TRANSPORTATION CABINET

CONTRACT ID NO. 13-9001
ADDENDUM # 3

Subject: Hopkins County
Letting December 6, 2013

- (1) Added - Section 11.1 Right of Way Negotiation Revision/Additions
- (2) Added - Section 17.10 Traffic Lighting Scope Clarification

COUNTY OF	ITEM NO.	SHEET NO.
HOPKINS	2-225.00	R7

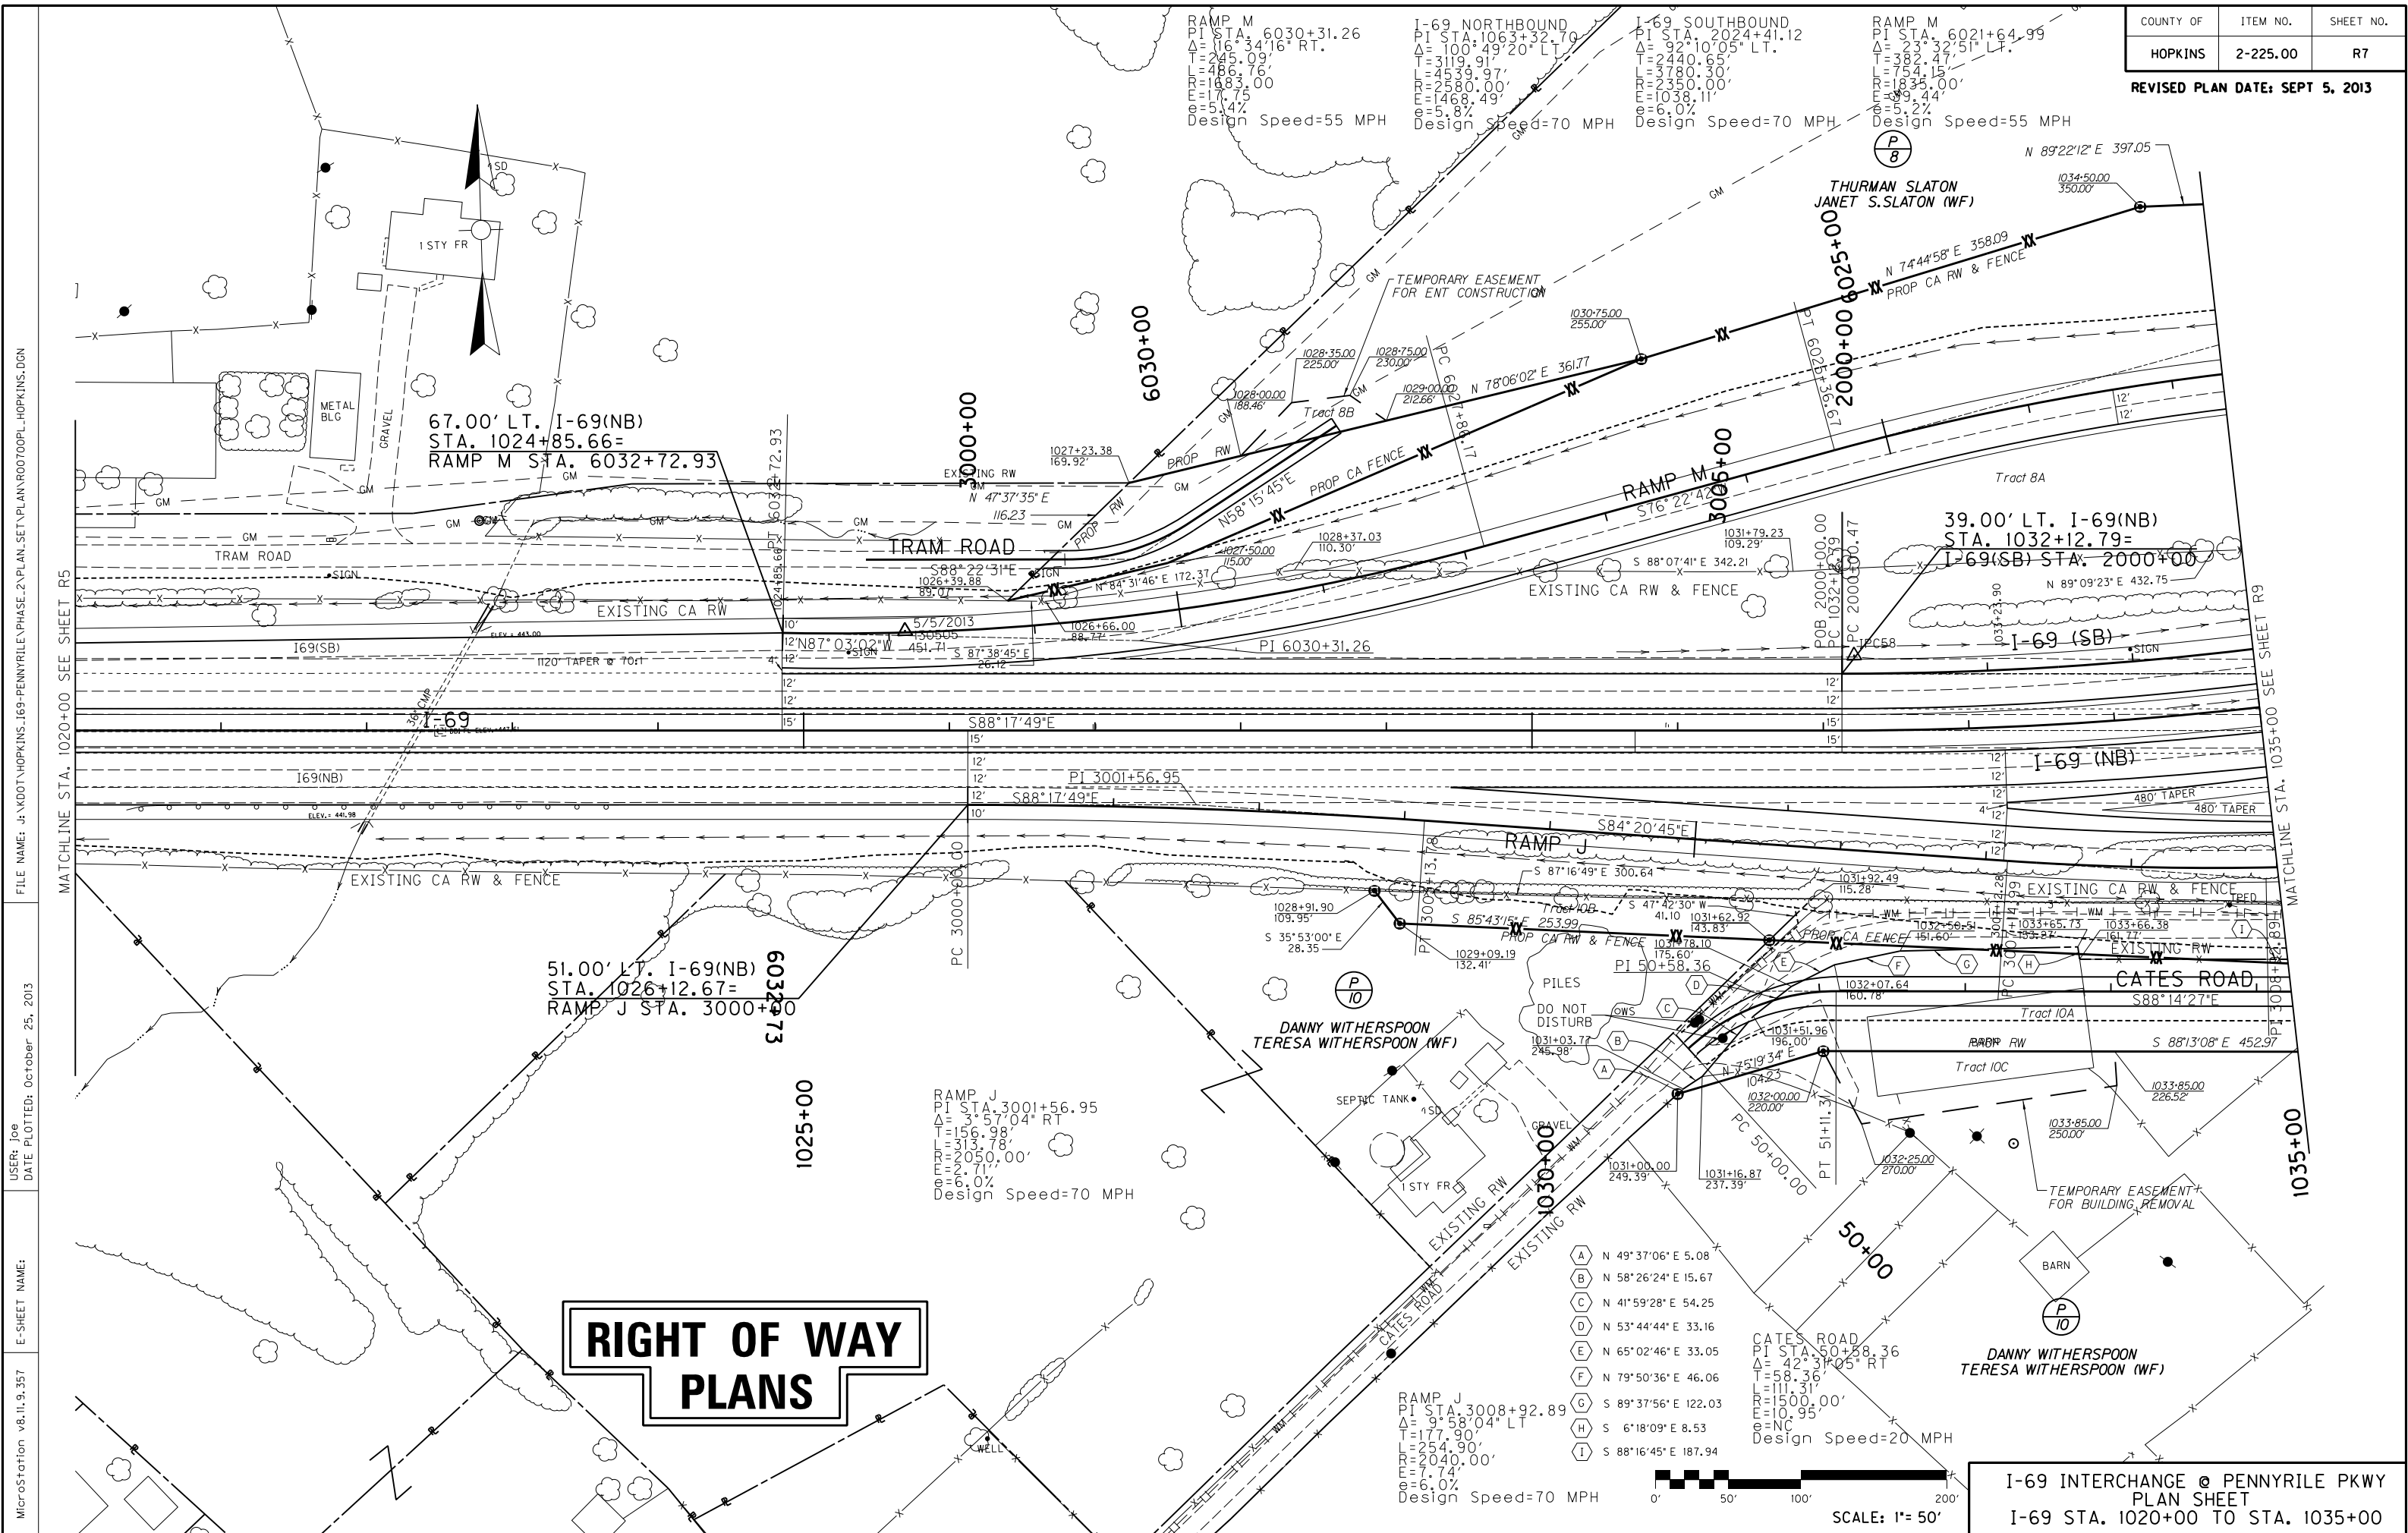
Parcel 10 – Utility Poles on left and right of Cates Road Relocation marked DO NOT DISTURB (see sheet R7 which is included for reference)

COUNTY OF	ITEM NO.	SHEET NO.
HOPKINS	2-225.00	R17

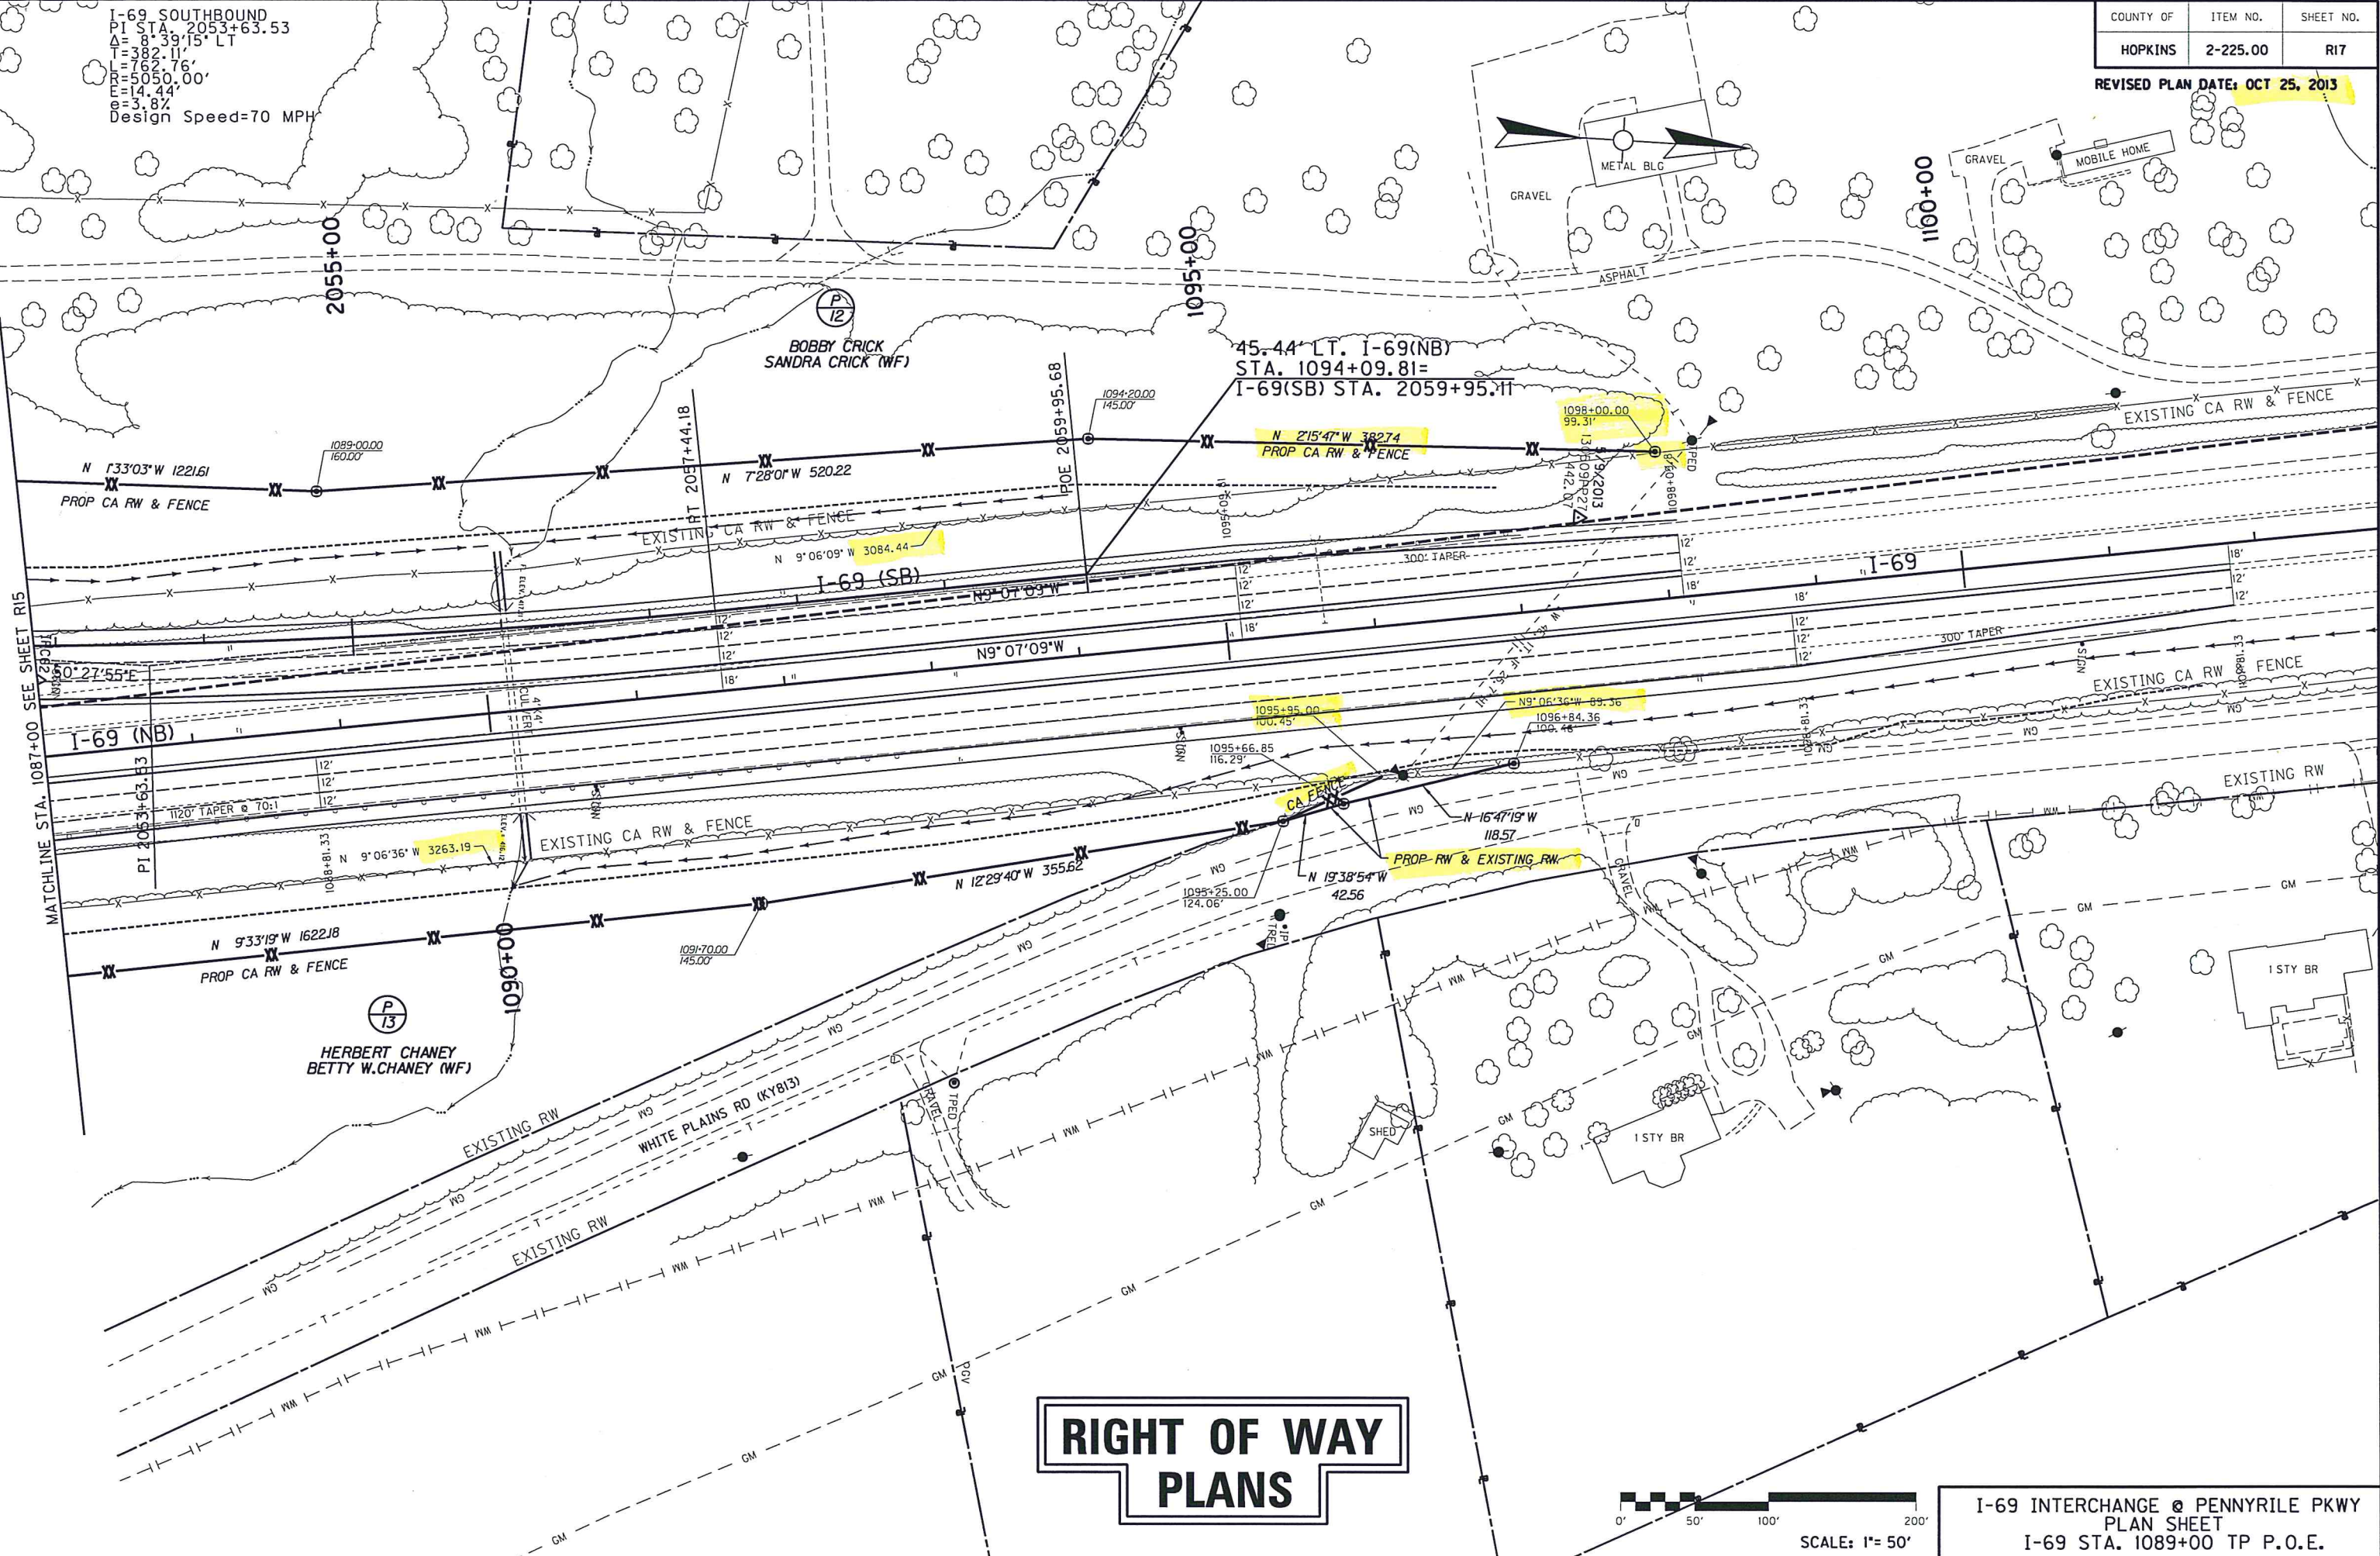
Parcel 12 – Proposed Right of Way & Control of Access Fence was modified to tie into existing Right of Way/Control of Access Fence at LT STA 1098+00.00 with an offset of 99.31 (left).

Parcel 13 – Control of Access Fence was modified to tie into existing C/A Fence at RT STA 1095+95.00 with an offset of 100.45 (right).
